#### LOCAL GOVERNMENT OFFICIAL INFORMATION AND MEETINGS ACT Request: 2023-42

## Form 13 Notice to fix No2

## CDC PLAYGROUND REVIEW STRUCTURAL ASSESSMENT AND STRENGTHENING

Figure 3. Playground Layout

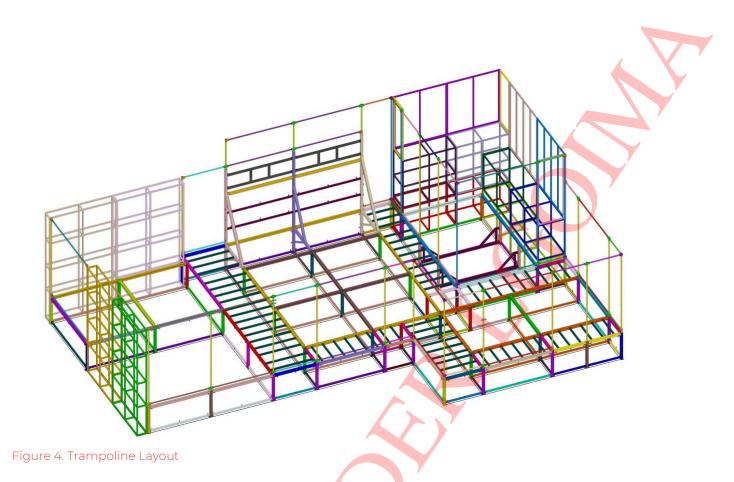
EQUIPMENT	COMMENTS	RECOMMENDATIONS
Large Playground	• The overall structure does not satisfy the lateral load criteria as per NZS 5828:2015.	<ul> <li>Add 9mm plywood in both transverse and longitudinal direction as shown in the attached sketch to satisfy the lateral load requirements</li> </ul>
Donut Slide	<ul> <li>The SHS columns and beams are able to resist the user loads as per NZS5828:2015.</li> <li>The 16mm thick plywood will resist lateral capacity as per NZS5828:2015 and NZS1170.5:2004.</li> </ul>	• No rectification required
Trampoline	<ul> <li>The trampoline structures are not sufficient for the user loading as per NZS5828:2015.</li> <li>The existing structural arrangement are not designed to resist lateral loadings as per NZS5828:2015.</li> </ul>	<ul> <li>Add 9mm plywood in both transverse and longitudinal direction as shown in the attached sketch to satisfy the lateral and vertical load requirements</li> </ul>

- Large Playground To add 9mm Plywood on each row at both transverse and longitudinal direction as marked in the strengthening sketches.
- Trampoline –To add 9mm Plywood on each row at both transverse and longitudinal direction as marked in the strengthening sketches.

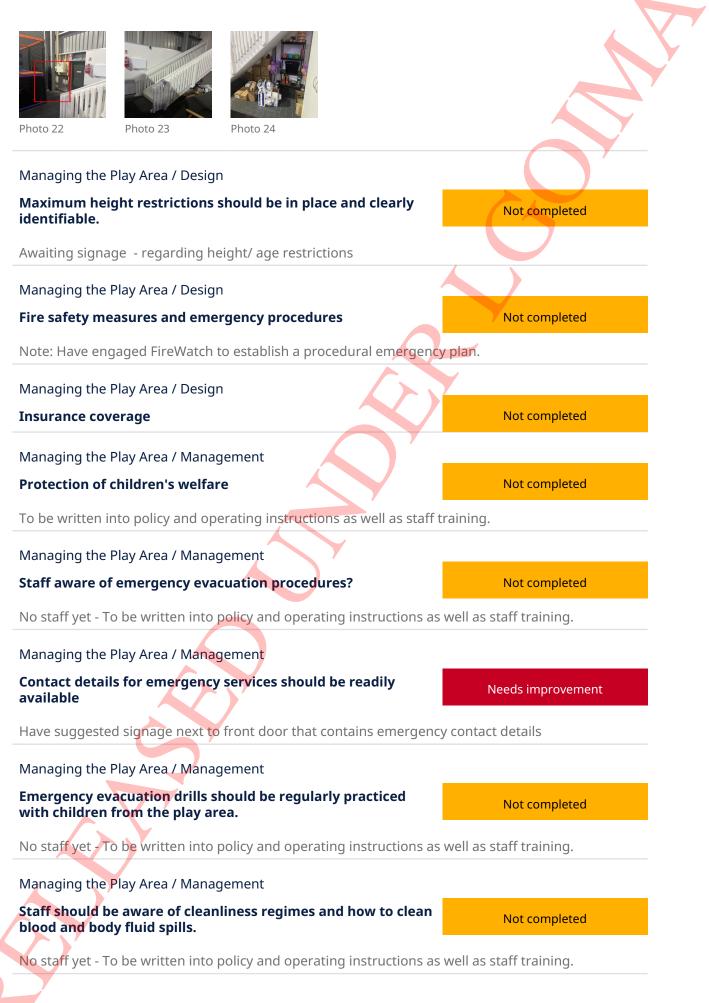
Blind spot next to fire brigade panel and office stairs. Under stairs storage area accessible.

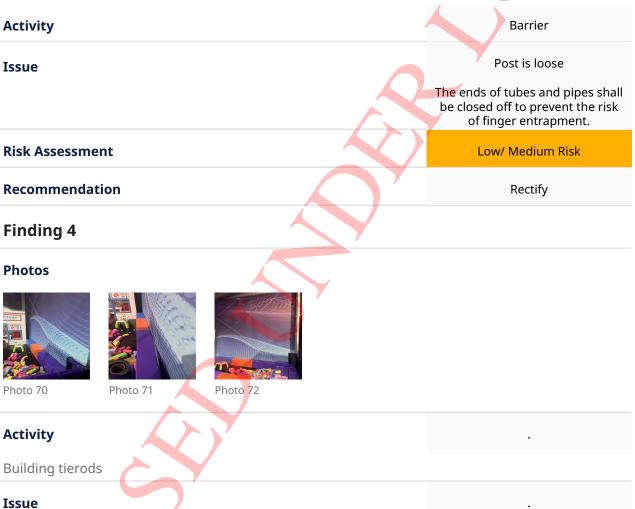
These are easily accessible from the ground and will most likely be climbed by adventuring children. I would suggest blocking/ covering the lower portion of them to remove accessibility

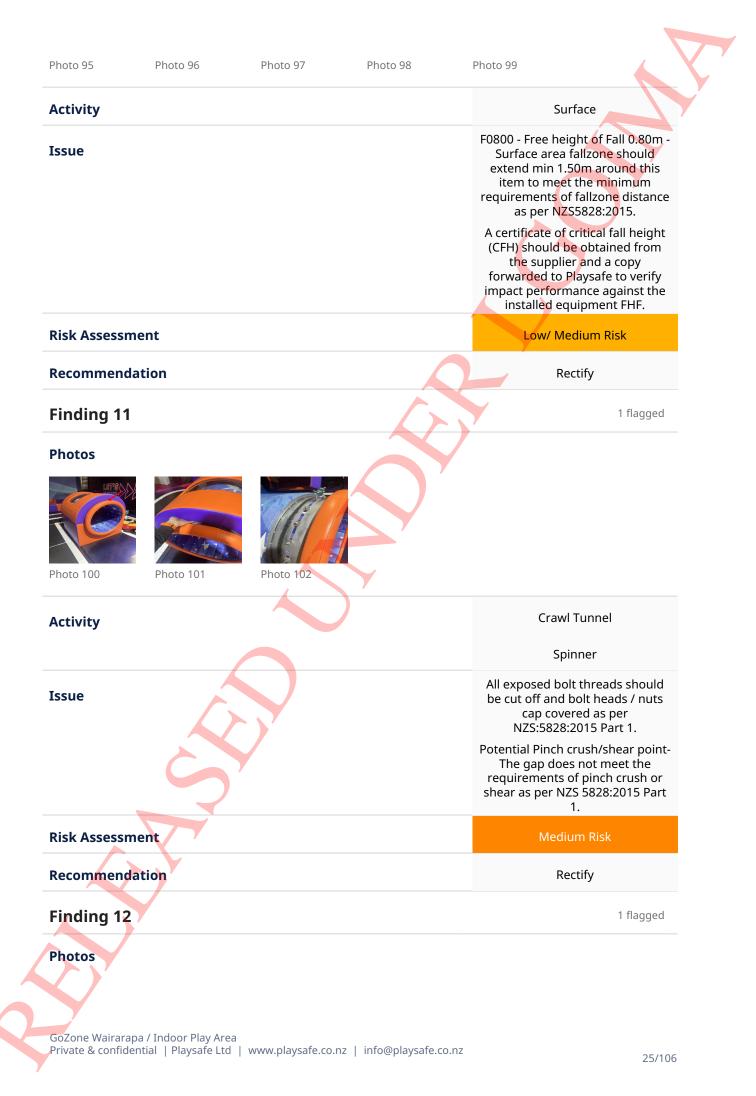
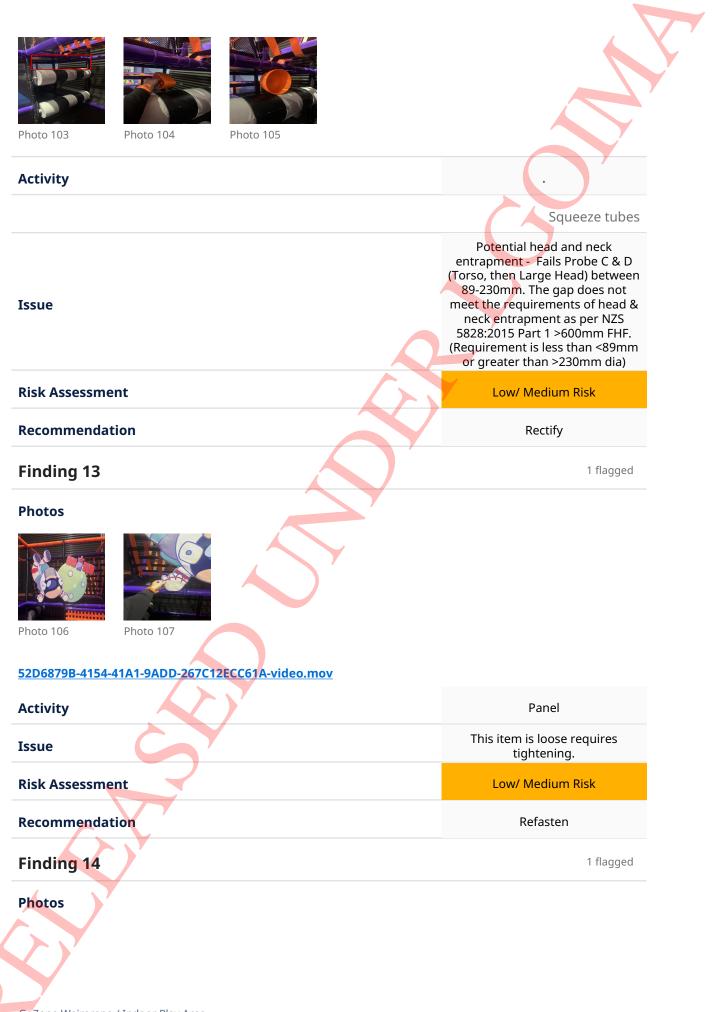
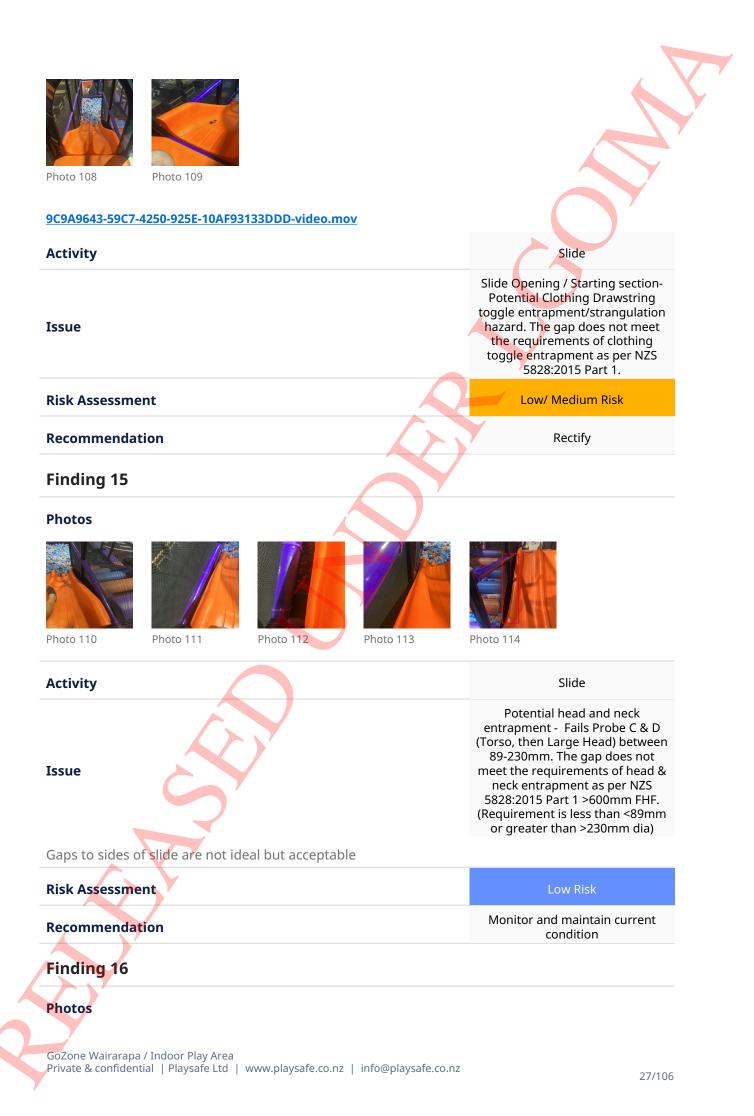
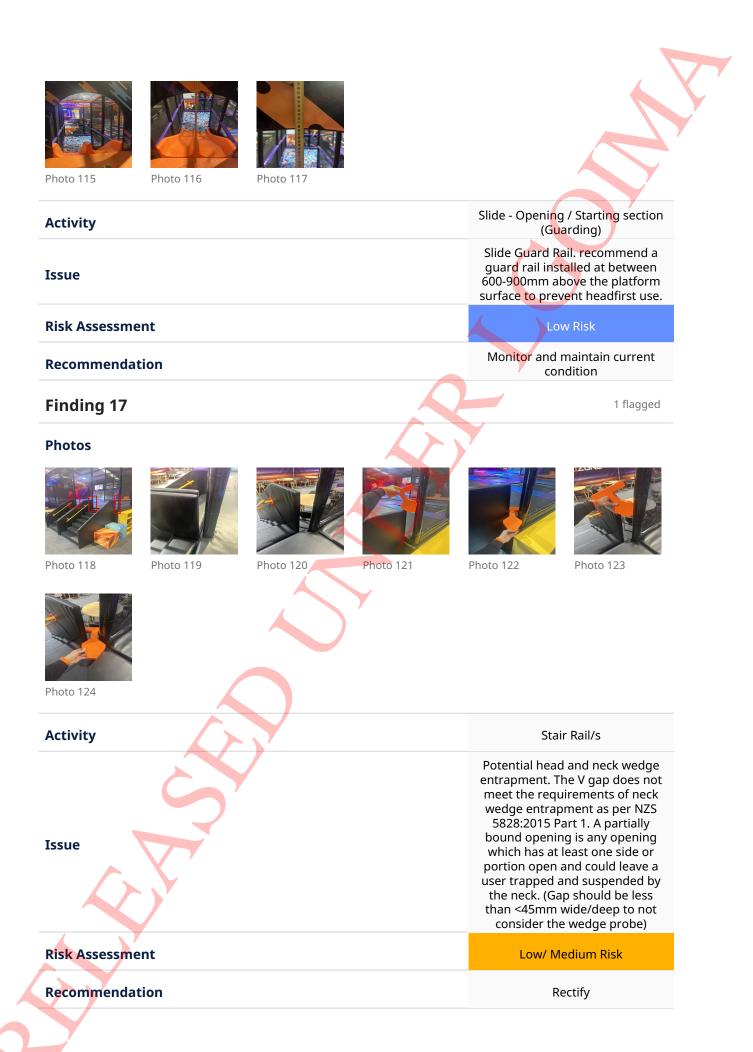
# Activity Fire house Excessive movement / racking on this item. Recommend further Issue bracing. Given the narrow, tall shape / This should be wall or floor mounted Low/ Medium Risk **Risk Assessment** Refasten Recommendation Reposition / Move 1 flagged **Finding 9 Photos** Photo 89 Photo 90 Photo 91 Photo 92 Photo 94 Photo 93 Activity Police station Potential head and neck entrapment - Fails Probe C & D (Torso, then Large Head) between 89-230mm. The gap does not meet the requirements of head & Issue neck entrapment as per NZS 5828:2015 Part 1 >600mm FHF. (Requirement is less than <89mm or greater than >230mm dia) **Risk Assessment** Low/ Medium Risk **Recommendation** Rectify Finding 10 1 flagged Photos -4

Rockwall

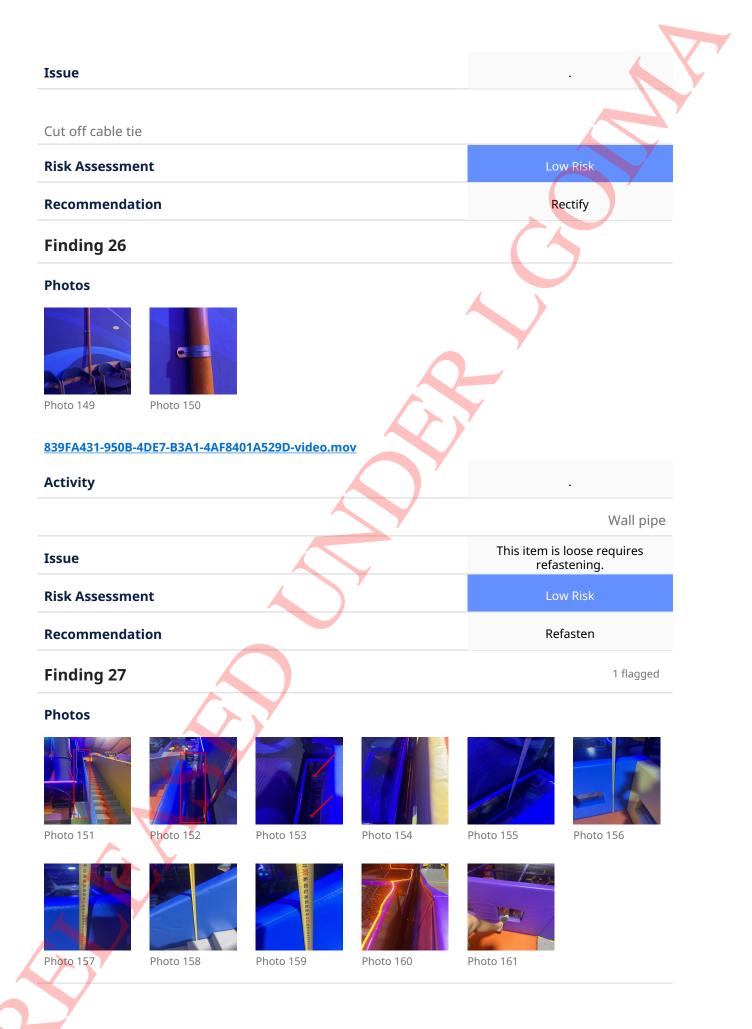
Activity body support height exceeds the maximum 3m free height of fall requirements of the NZ5828:2015. Falls from these heights could pose life-threatening head neck or back injury.

I would suggest some tows of rocks are removed and/or a reverse return is added to eliminate the possibility of climbing ontop.

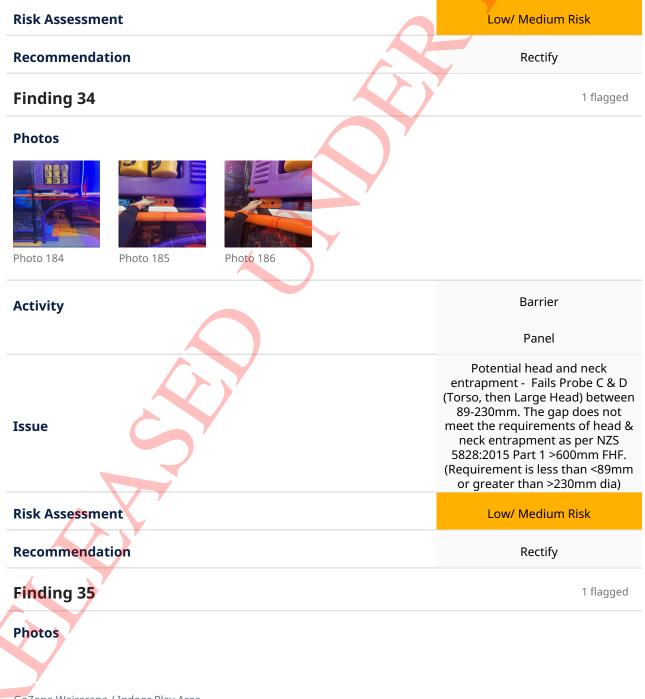
Potential head and neck wedge entrapment. The V gap does not meet the requirements of neck wedge entrapment as per NZS 5828:2015 Part 1. A partially bound opening is any opening which has at least one side or portion open and could leave a user trapped and suspended by the neck. (Gap should be less than <45mm wide/deep to not consider the wedge probe)

Th gaps above the fixed panels and the revolving panels are a A/B probe non-compliance. They are a position 2 wedge as per EN 1176 and ideally the gaps between the top of these panels and structure above should be less than 45mm or over 230mm
